Access Compliance Report

(Curb Ramps)

Intersection ID: 2941	Main Street: GOLDENFIELD_DR	Cross Street: SUMMER_CREEK_LN	Location:	E
ADA ID: 79FACEBAB8FF	Ramp Type: Perp	Initial Pass/Fail: Fail	Overall Compliance: No	Severity Score: 22.5
Codes/Mitigation Info/Possible Solution		Field Measurements/Component Compliance

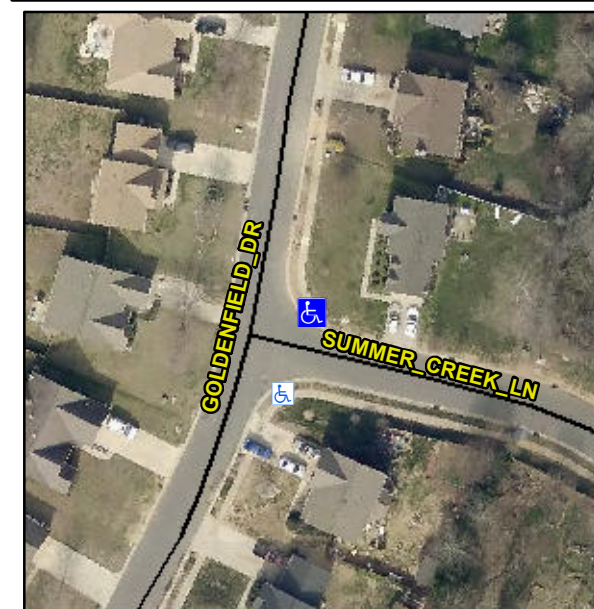
Not Found, R304.5.1, R304.2.2, R304.5.3

Compliance	Description	Data	Compliance	Description	Data
N/A	Ramp Length (in)	45.0	No	Ramp Slope (%)	10.1
No	Ramp Width (in)	43.5	No	Ramp XSlope (%)	3.6
N/A	Flare Type LT	N/A	N/A	Flare Type RT	N/A
N/A	Flare Slope LT (%)	N/A	N/A	Flare Slope RT (%)	N/A
N/A	Flare Traversable LT?	N/A	N/A	Flare Traversable RT?	N/A
N/A	Landing Length (in)	N/A	N/A	DWS Provided?	N/A
N/A	Landing Width (in)	N/A	N/A	DWS Contrast?	N/A
N/A	Landing Slope (%)	N/A	N/A	DWS Length (in)	N/A
N/A	Landing X Slope (%)	N/A	N/A	DWS Full Width?	N/A
N/A	Landing Curb? (Y/N)	N/A	N/A	DWS Offset (in)	N/A
N/A	Shared Landing?	N/A			
N/A	Gutter Ponding?	N/A	N/A	Gutter Slope (%)	N/A
N/A	Gutter Lip Ht (in)	N/A	N/A	Gutter X Slope (%)	N/A
N/A	Painted X Walk1?	No	N/A	Painted X Walk2?	N/A
	X Walk 1 Direction	To SW		X Walk 2 Direction	N/A
N/A	X Walk 1 Width (in)	N/A	N/A	X Walk 2 Width (in)	N/A
	X Walk 1 Slope (%)	0.6		X Walk 2 Slope (%)	N/A
	X Walk 1 X Slope (%)	1.3		X Walk 2 X Slope (%)	N/A

Remove & Replace Entire Ramp.
